RE: Contract Documents
Town of Ayer, Massachusetts
Ayer Wastewater Treatment Facility – FY2019 Improvements
Contract No. 20DPW02

ADDENDUM NO. 3

Town of Ayer, Massachusetts Ayer Wastewater Treatment Facility – FY2019 Improvements

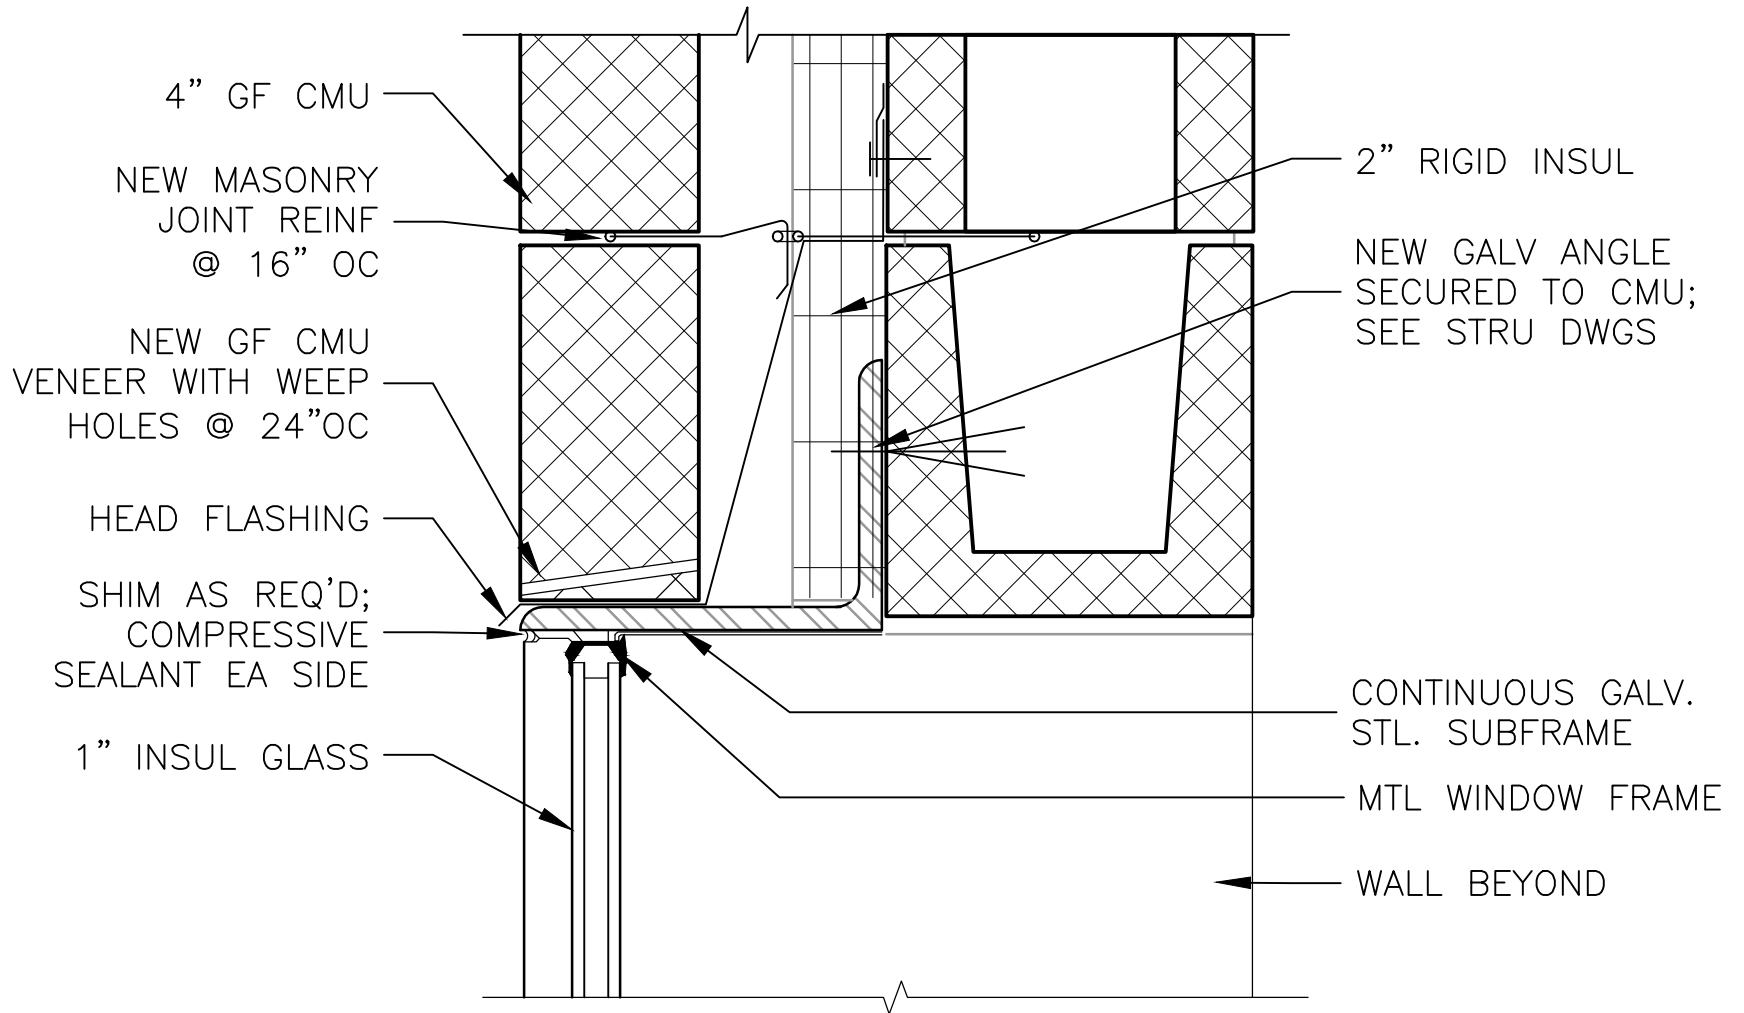
Q3. Please reference drawing S – 2 detail “A”. Could you please elaborate on the scope of work involved with this column?

A3. There is no column at (column line) location D8 at present. Contractor to install column at this location in accordance with the plans and specifications.

SK-A-1

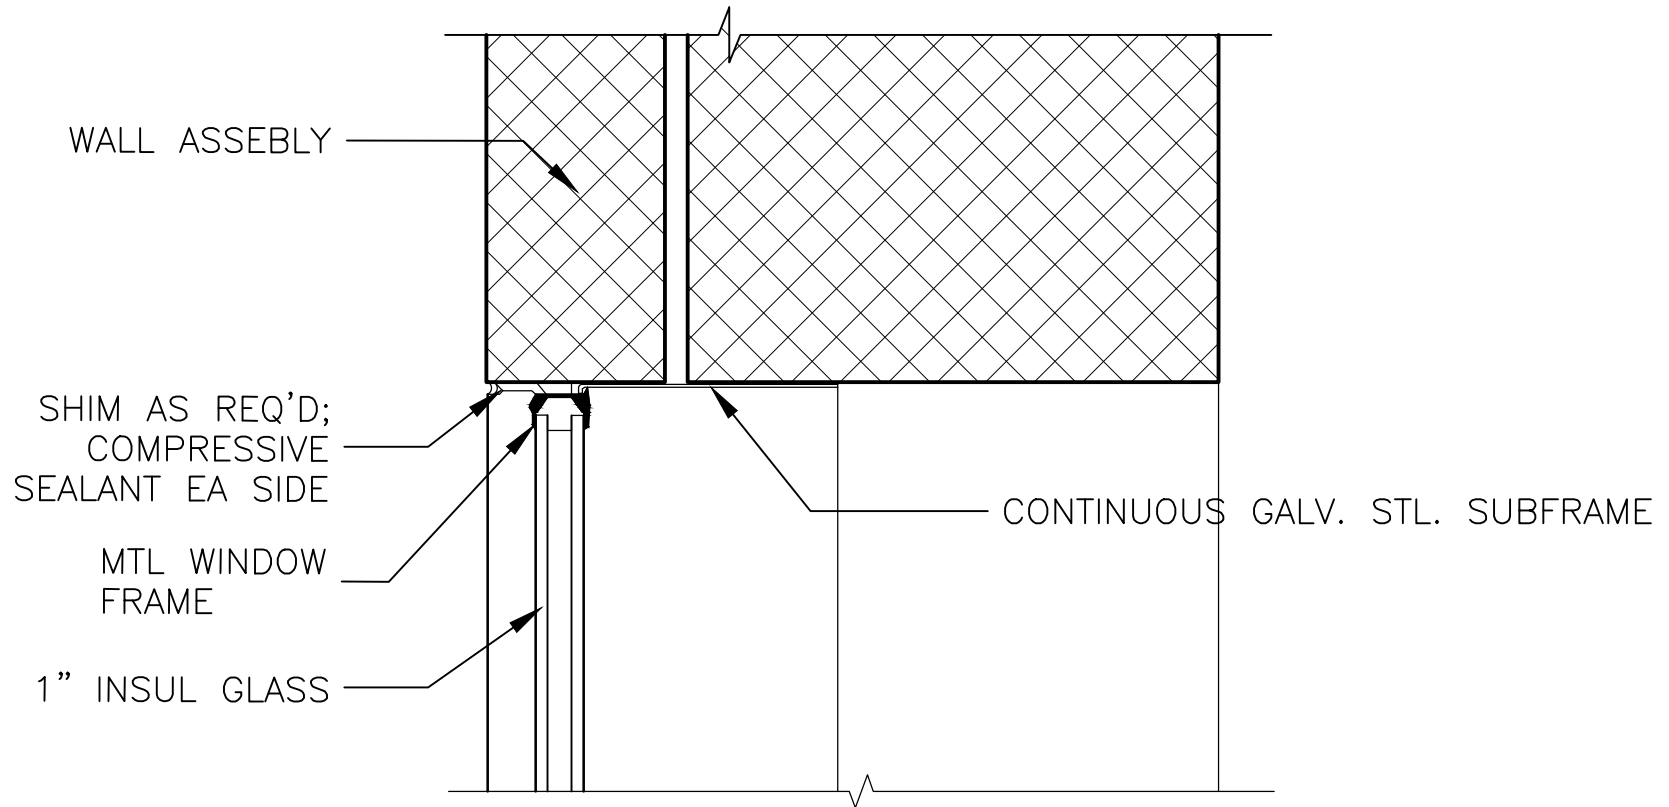
1. Location A1-B2, DELETE DETAIL 1 and REPLACE with the contents of SK-A-1.
2. Location A2-B3, DELETE DETAIL 2 and REPLACE with the contents of SK-A-2.
1. Location A3-B4, DELETE DETAIL 3 and REPLACE with the contents of SK-A-3.
